PROJECT NAME: Alvarado Intermediate School Partial Modernization
BID NO: 2010/11:13
DSA NO: 03-112358

ADDENDUM NO: 4
DATE: May 12, 2011

ADDENDUM NO. 4

Rowland Unified School District Alvarado Intermediate School Partial Modernization

AD4-A2A

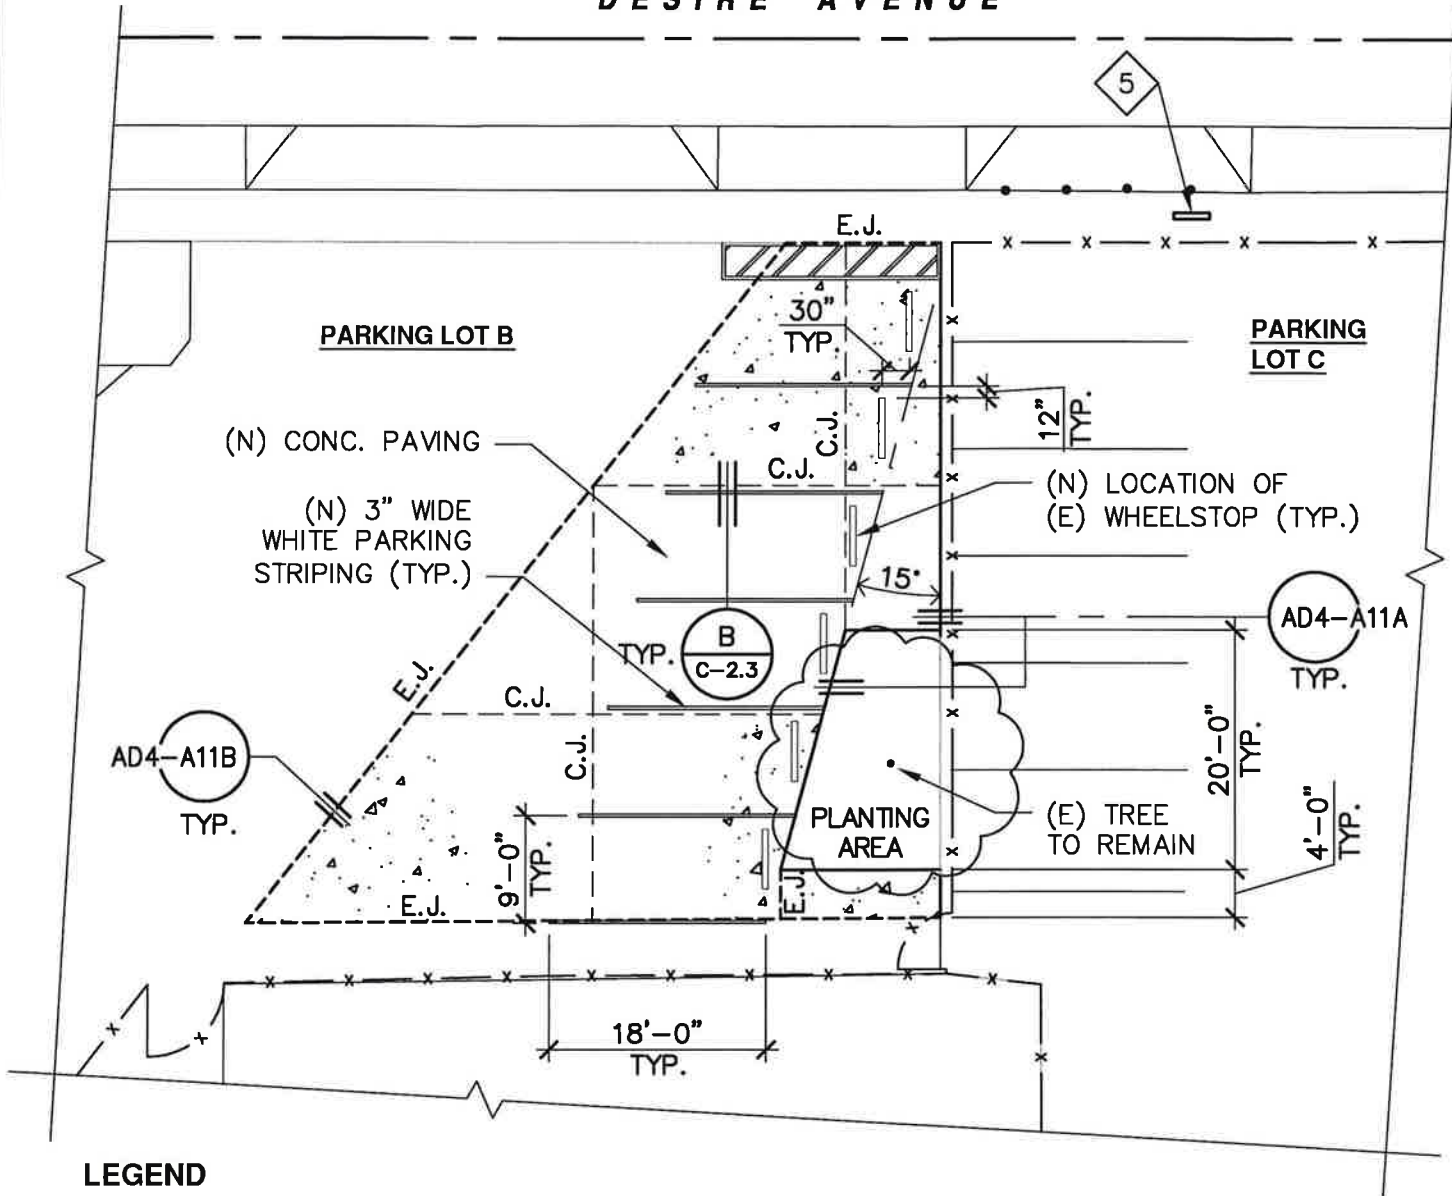
12. REVISE: Per attached drawings **AD4-A2A**, **AD4-A2B**, **AD4-A3A**, and **AD4-A3B**, dated May 10, 2011.

AD4-A2B

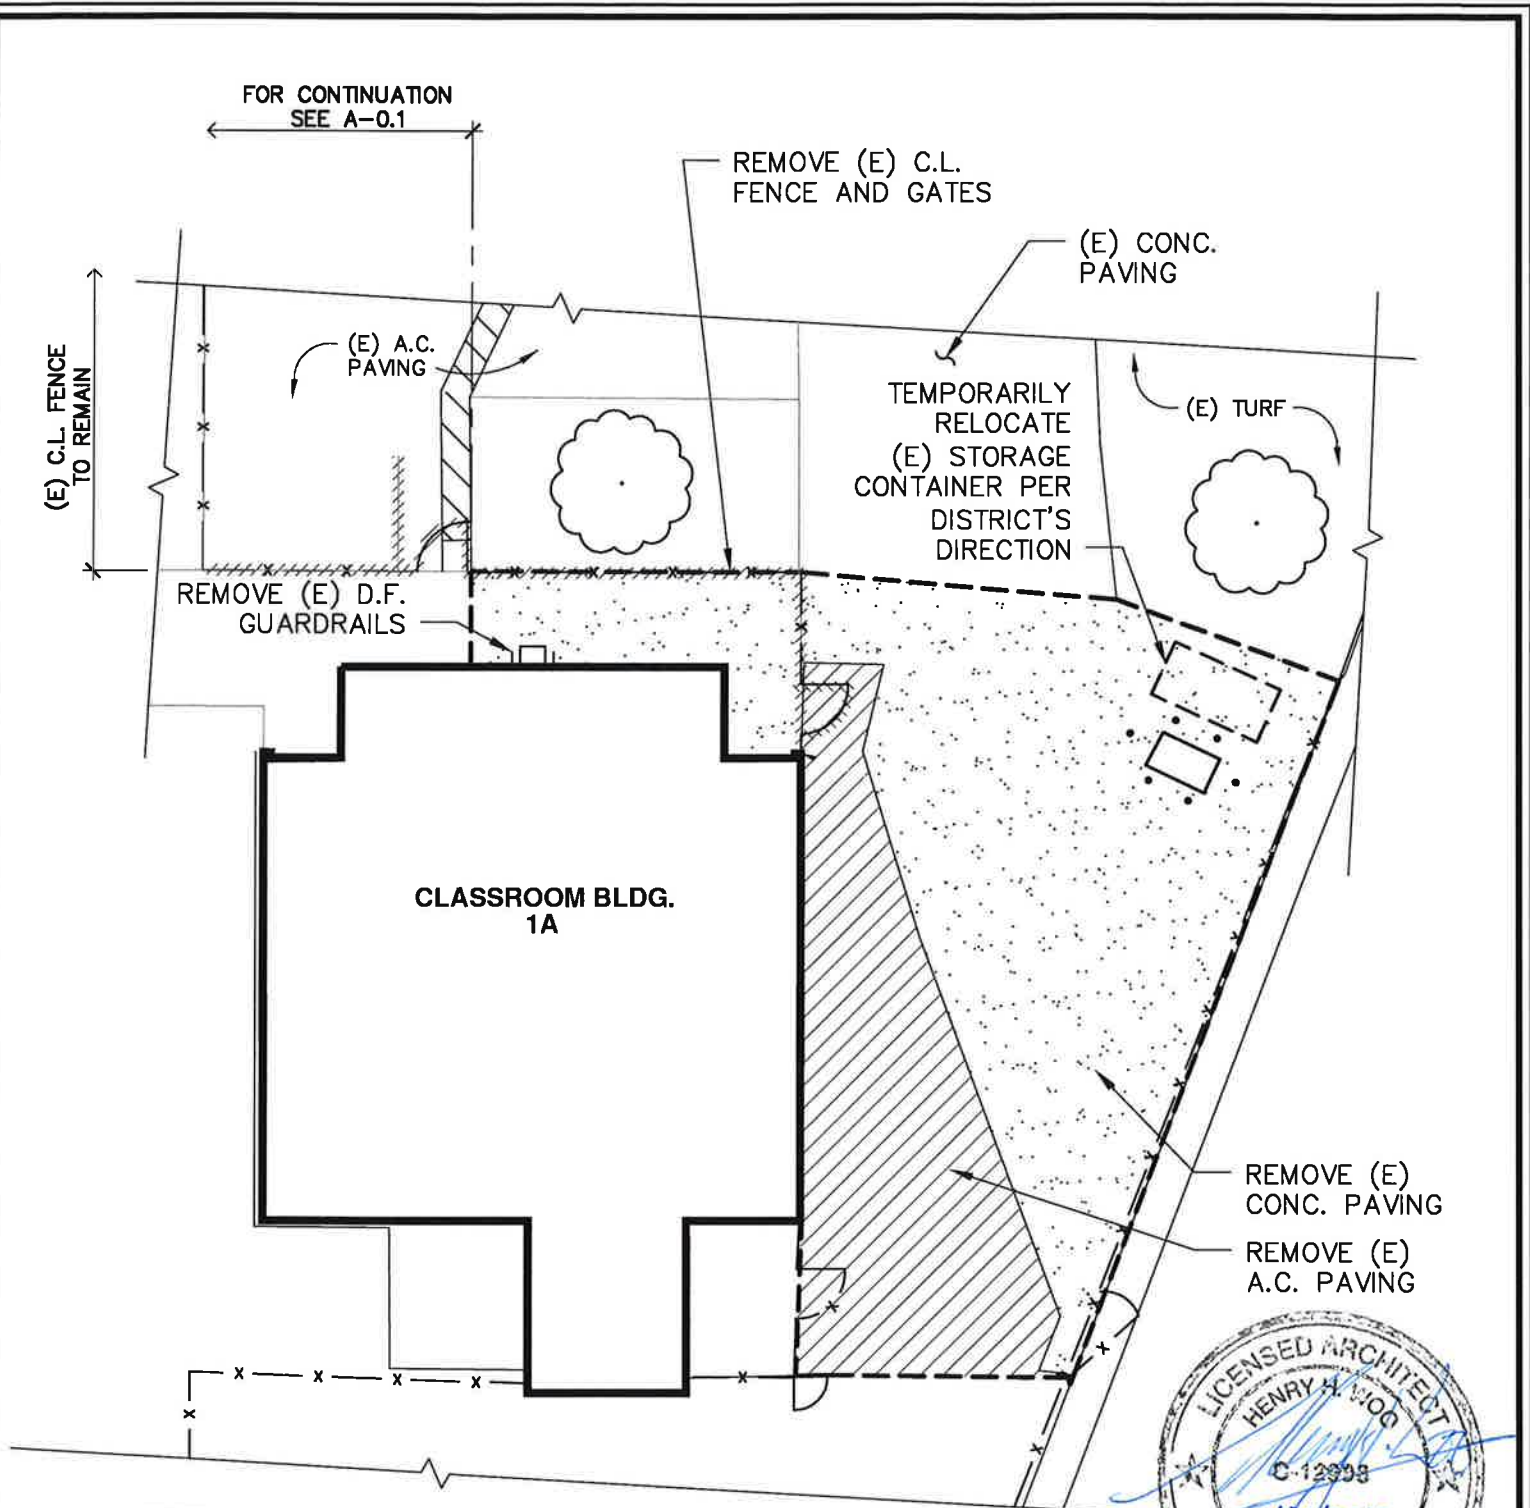
1. REMOVE (E) BOLLARDS ((6) TOTAL) FOR (N) CONC. PAVING AND INSTALL (N) BOLLARDS AT THE SAME LOCATION (SEE DETAIL AD4-A3D)
2. THIS DRAWING IS INTENDED AS A GENERAL DEMOLITION PLAN. CONTRACTOR SHALL INCLUDE ALL OTHER INCIDENTAL DEMOLITION NOT SPECIFICALLY INDICATED ON THIS PLAN BUT REQ'D TO ACCOMPLISH ALL WORK.

AD4-A4

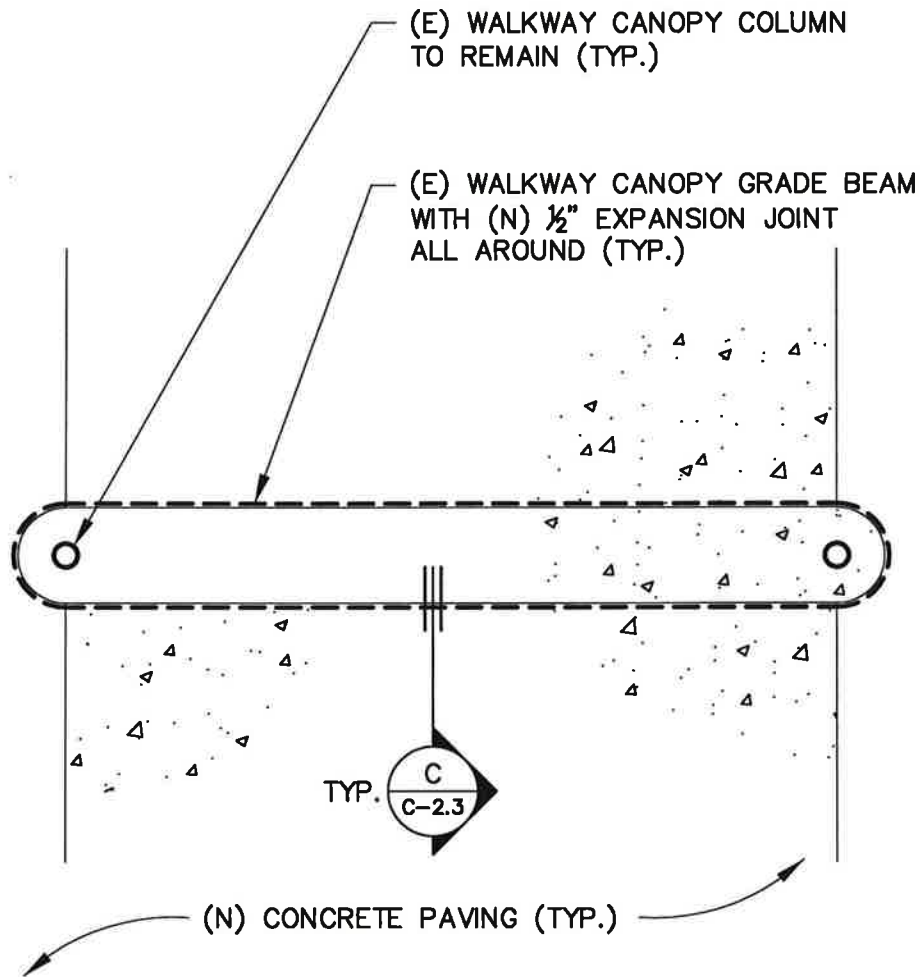
16. REVISE: To add a ceiling hatch in Room RSP-C3-4B per attached drawing **AD4-A4**, dated May 10, 2011.

AD4-A6

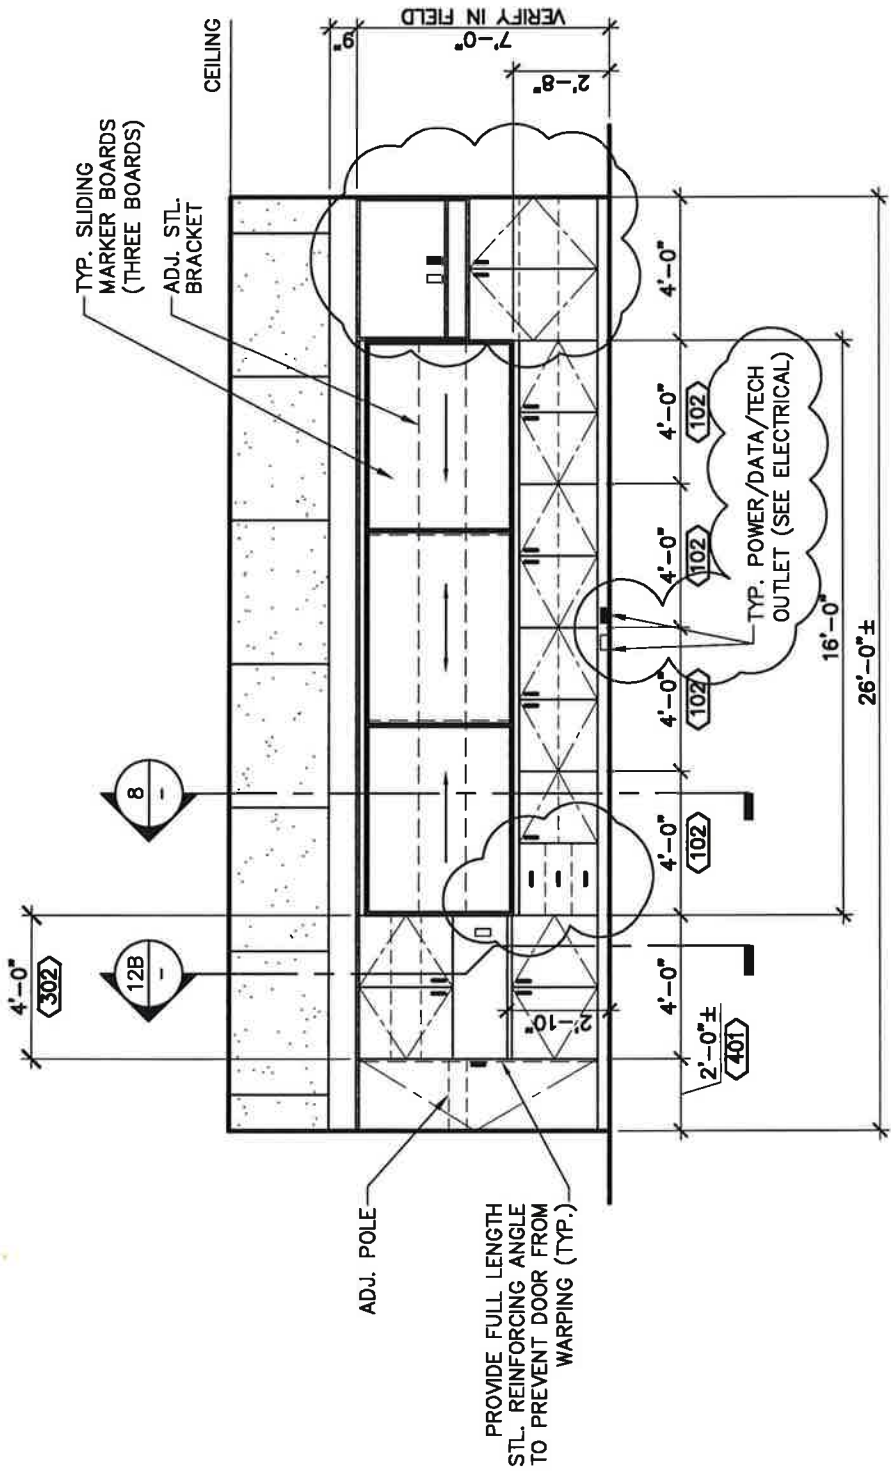
13. REVISE: Existing floor slab demolition scope per attached drawings **AD4-A6**, dated May 10, 2011.

CONTRACTOR SHALL BE RESPONSIBLE FOR REMOVAL OF ALL EXISTING SLAB, DEPRESSED SLAB, AIR FLOW SLAB, AND UNDER FLOOR TUNNEL. CONTRACTOR SHALL PROVIDE ANY ADDITIONAL FILL AS REQUIRED.

AD4-A9A DATE: 5/10/2011

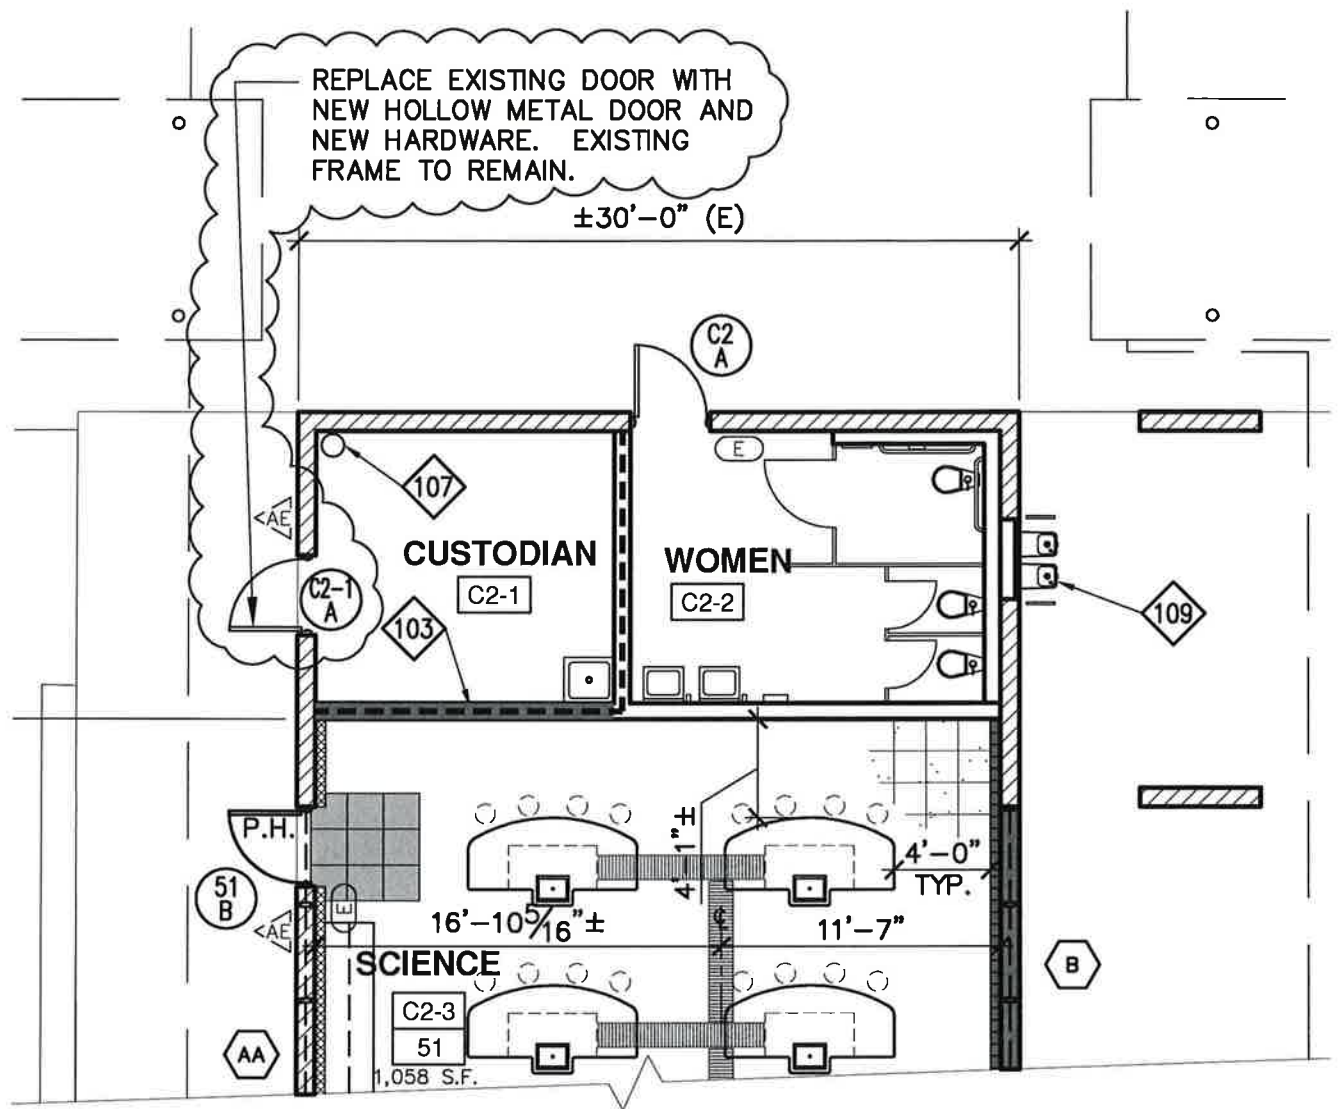
14. REVISE: Per attached drawings **AD4-A9A**, **AD4-A9B**, **AD4-A9C**, and **AD4-A9D**, dated May 10, 2011.

AD4-A9B

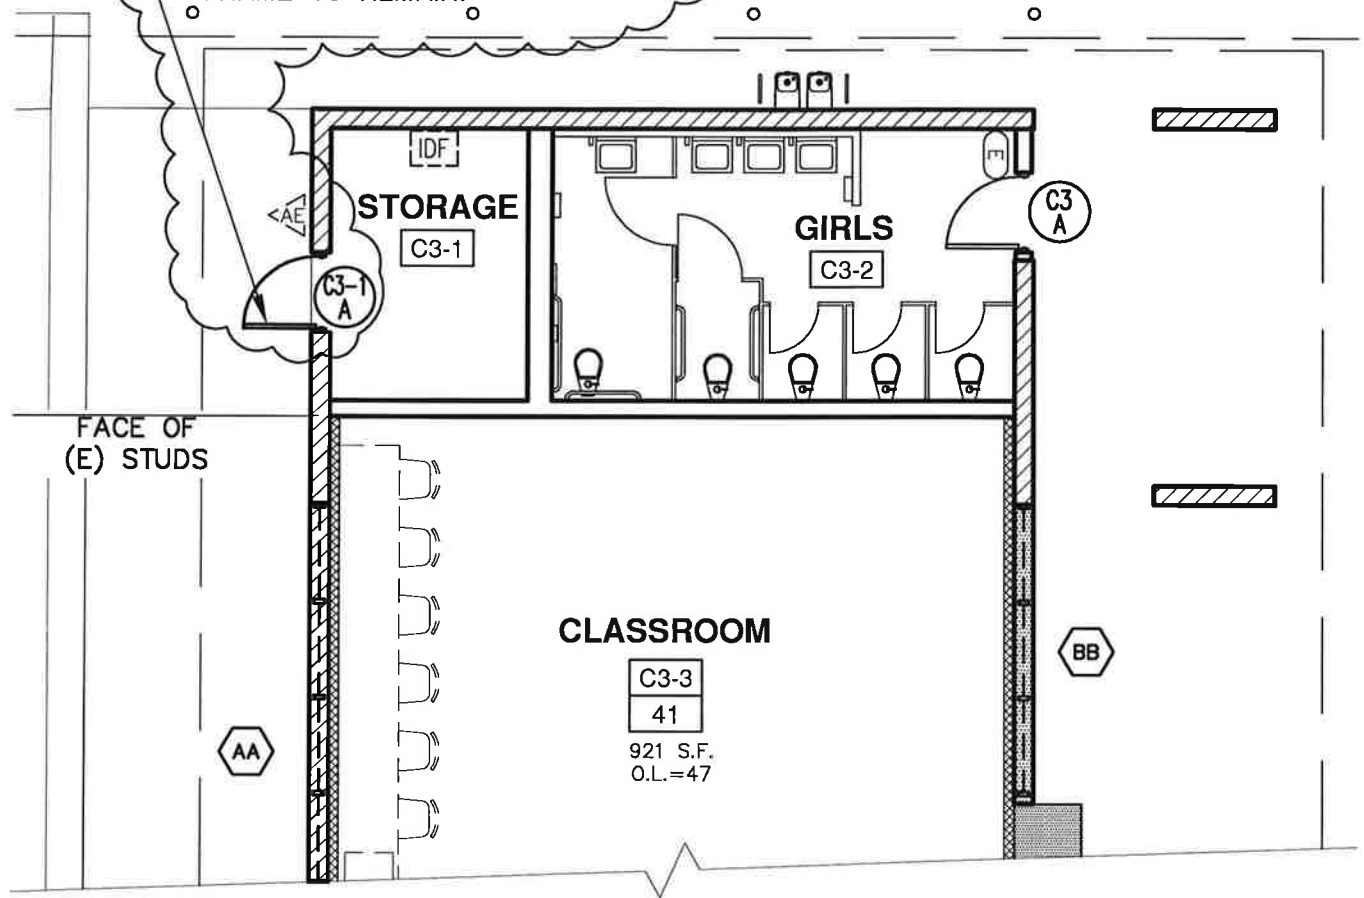
REPLACE EXISTING DOOR WITH
NEW HOLLOW METAL DOOR AND
NEW HARDWARE. EXISTING
FRAME TO REMAIN.

AD4-A10A DATE: 5/10/2011

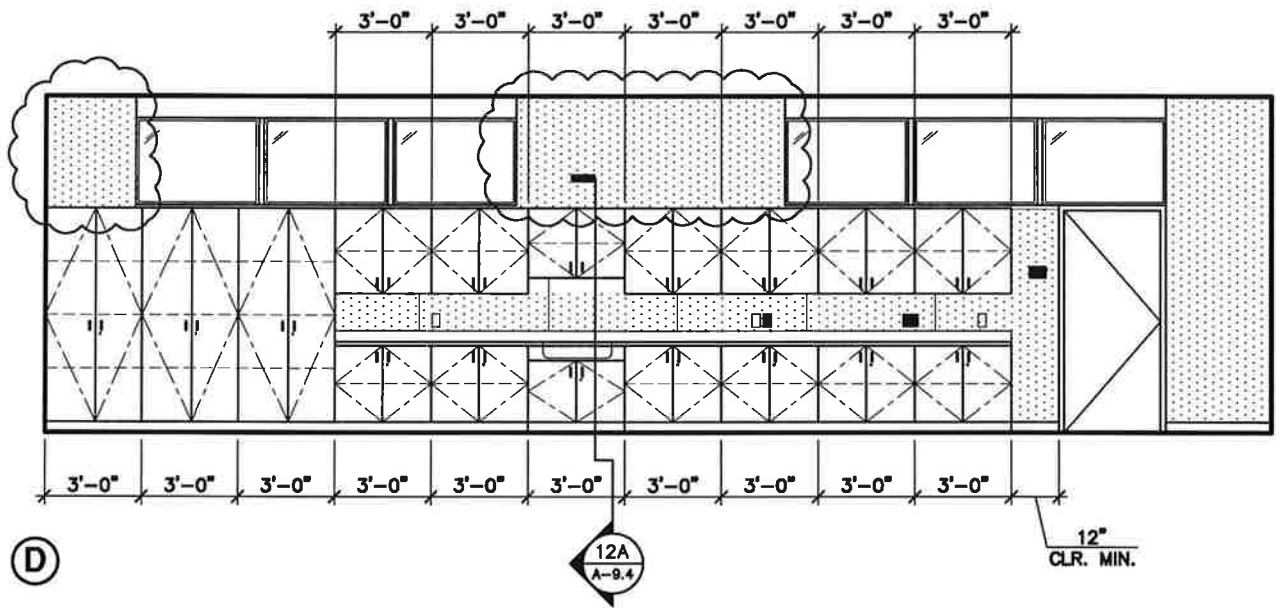
17. REVISE: Per Attached drawing **AD4-A10A**, dated May 10, 2011.

AD4-A10B DATE: 5/10/2011

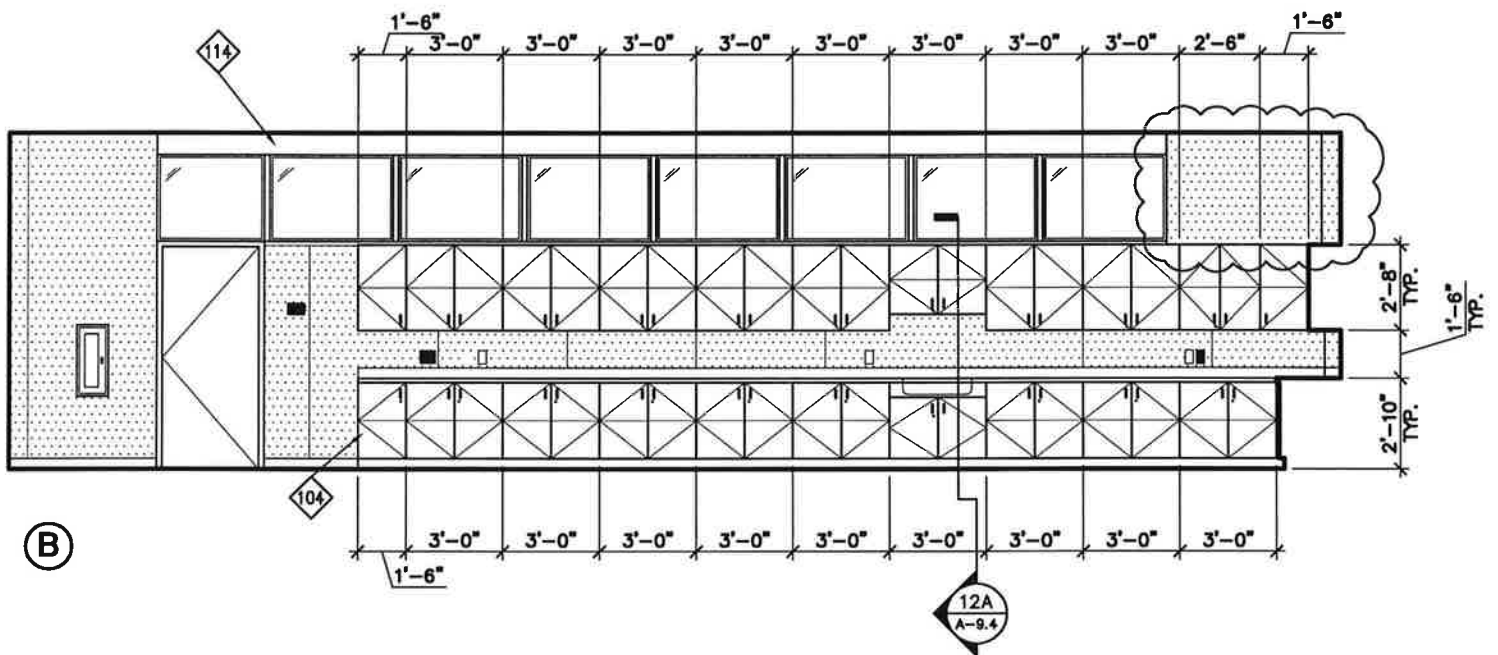
18. REVISE: Per Attached drawing **AD4-A10B**, dated May 10, 2011.
